THE CORPORATION OF THE CITY OF MARKHAM

Addendum #1

**Bid Opportunity: 143-T-17 - Fire Station 94 and 96
Renovations for Gender Diversity**

ARCHITECTURAL ADDENDUM NUMBER ONE
MARKHAM - RENOVATIONS TO FIRE STATIONS NOS. 94 & 96
JUNE 5, 2017

Plan - Exterior

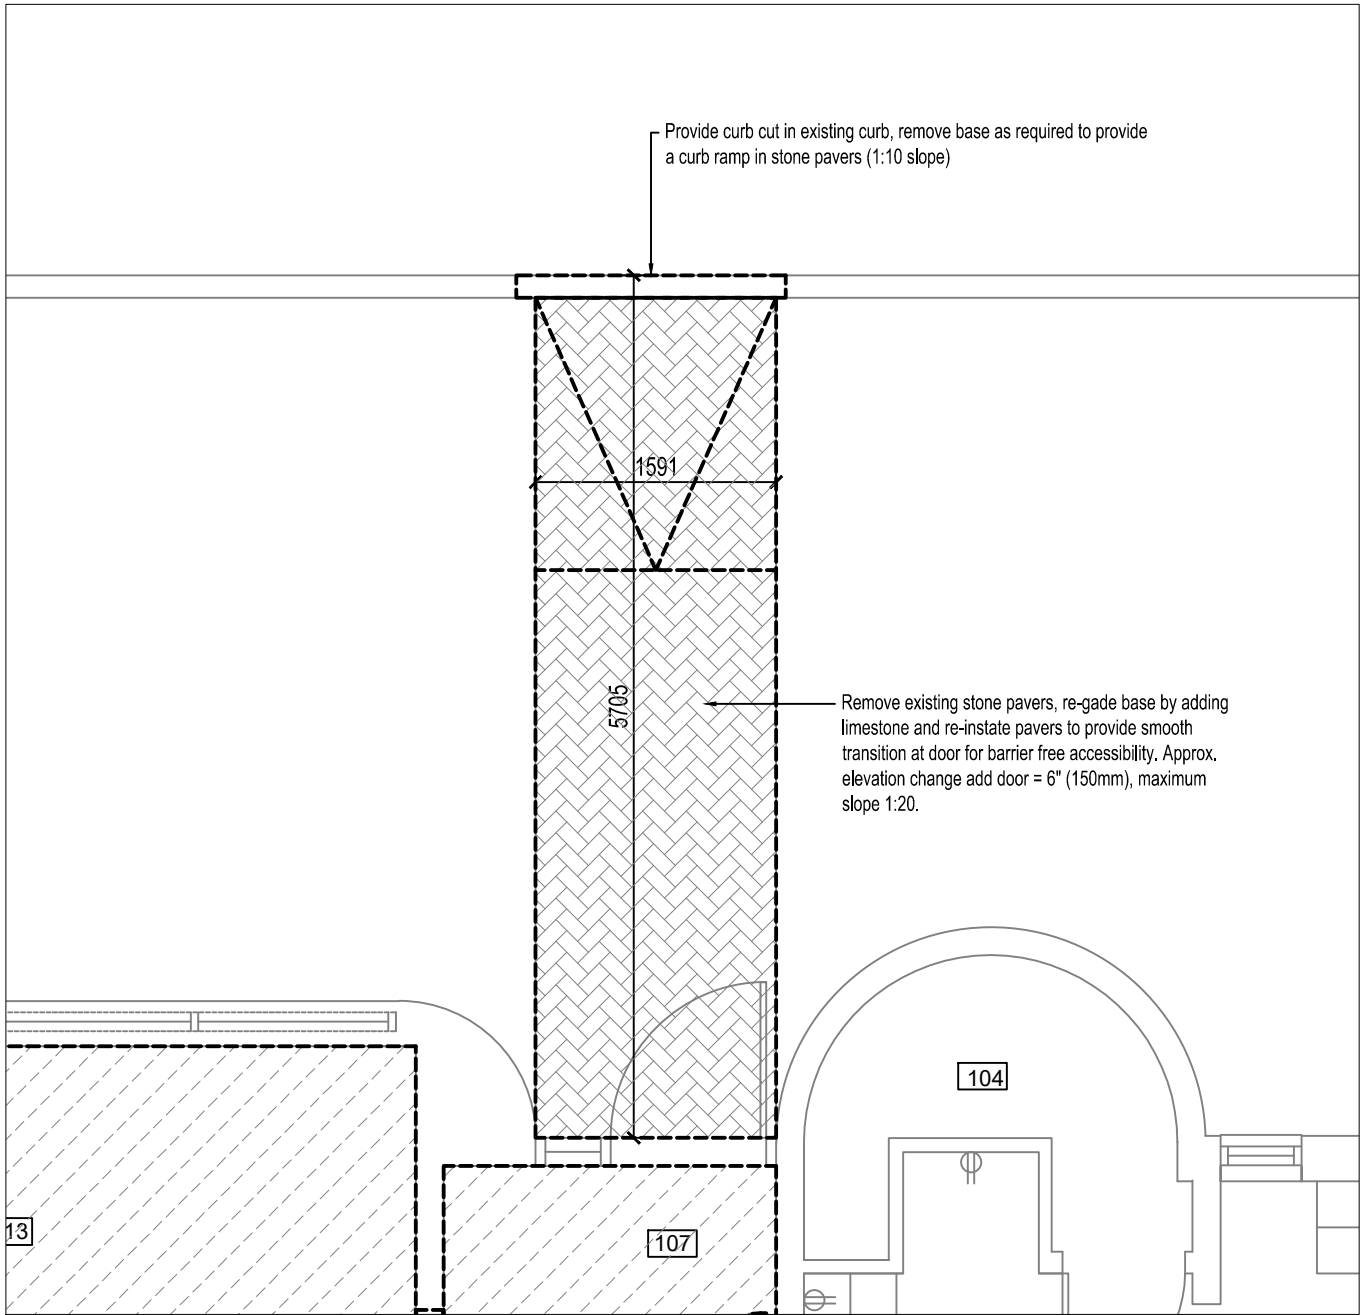
- .1 At Door 02, assume use of Acrovyn SCR-40N where frame is removed from finished floor to ceiling. Colour to Architect's Later Selection.
- .2 See attached Sketch A101.1 detail for exterior Work.

Sketch 97.1
 May 29, 2017

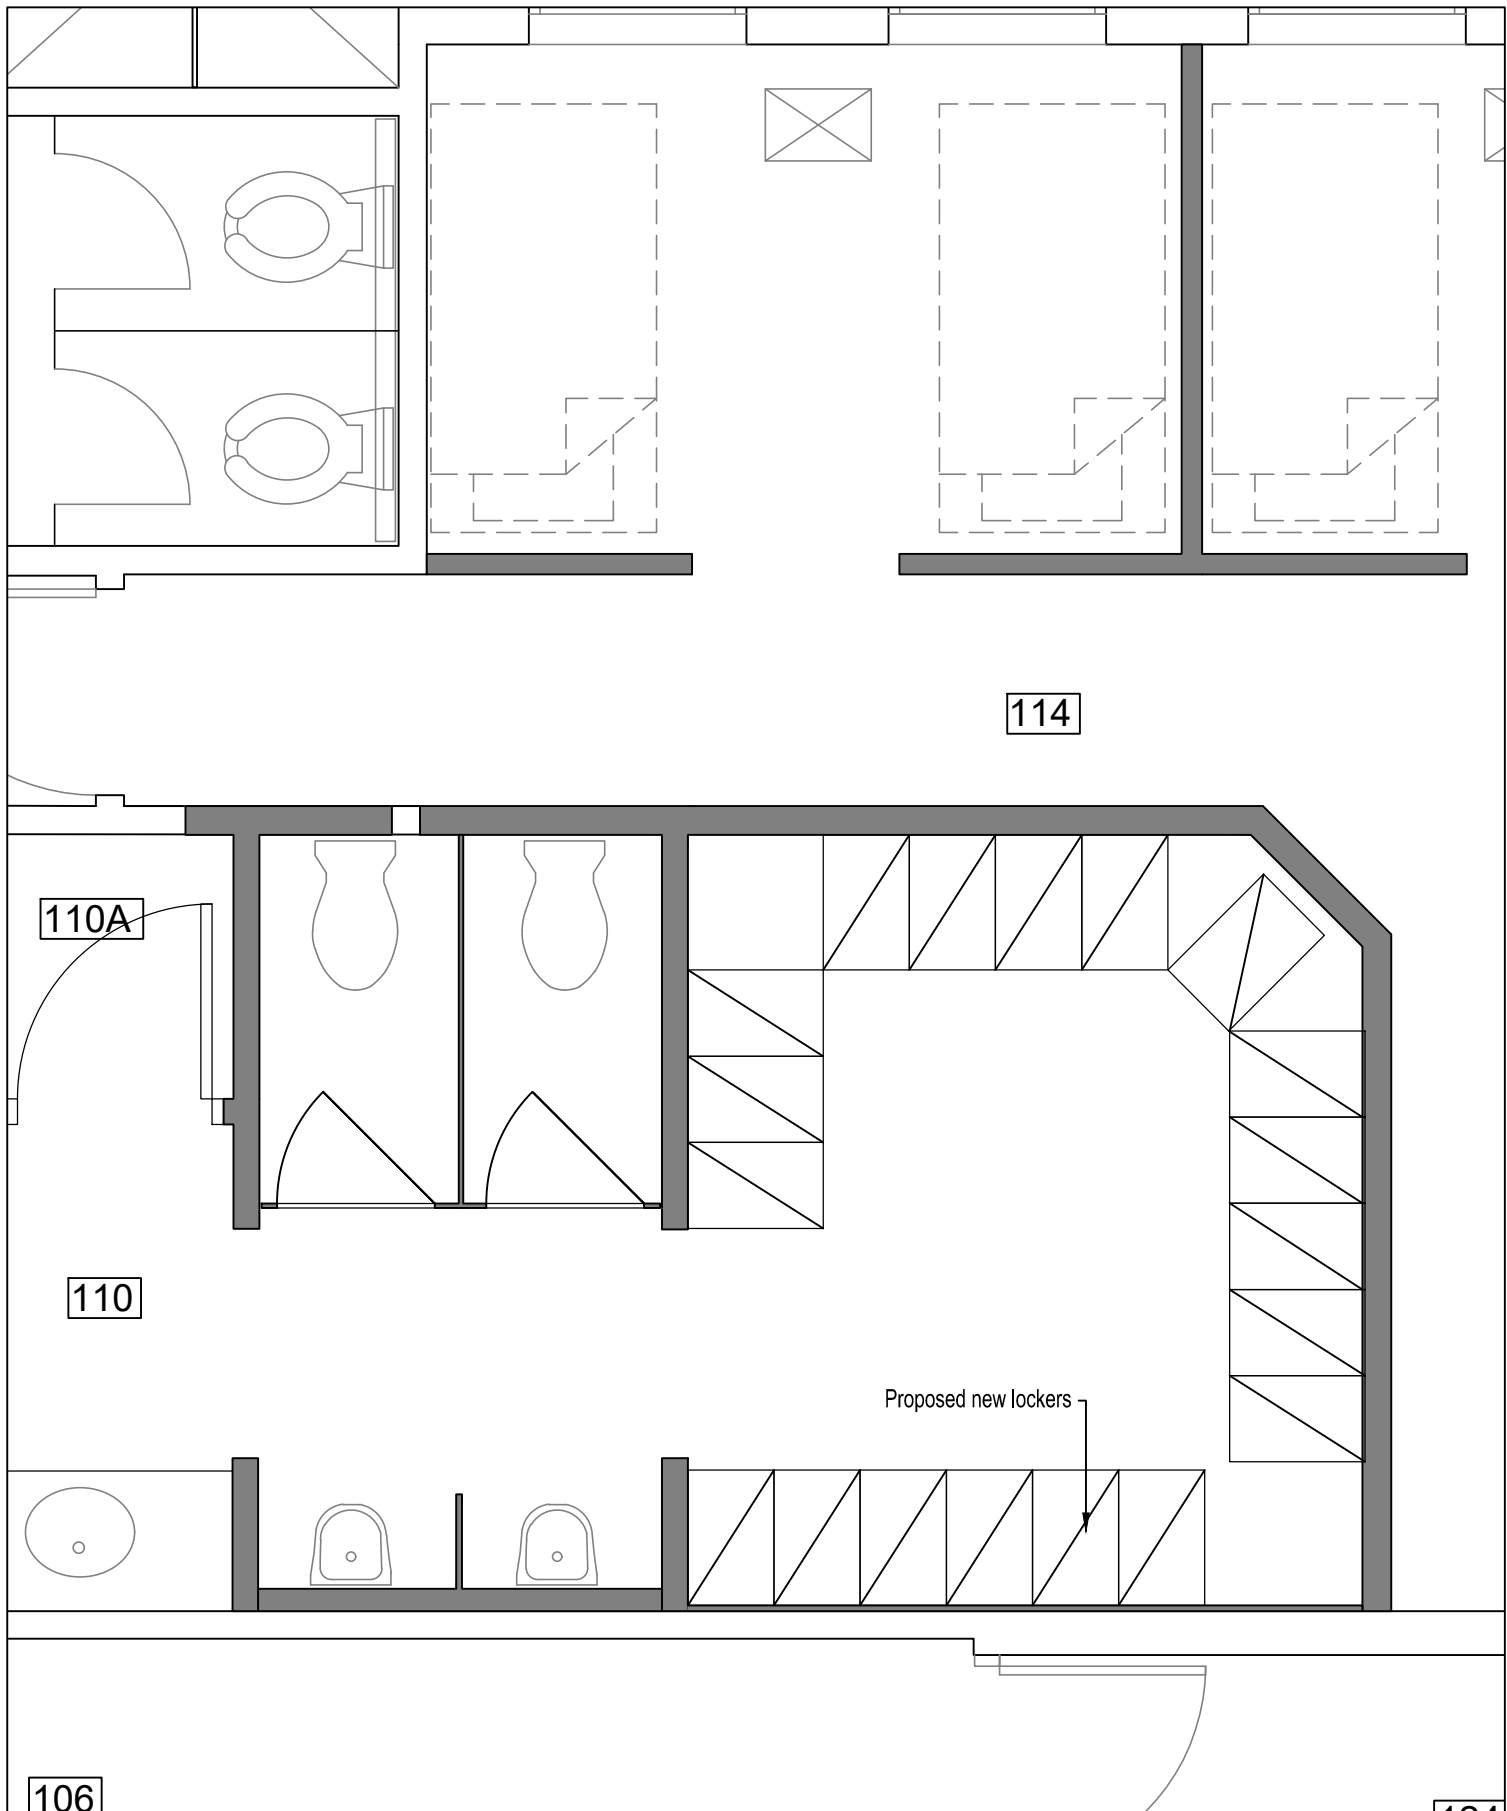
- .1 **Section 10900 - Item 4.3**
 - .1 See attached Sketch SK-97.1 of layout of lockers at **Station 97**.
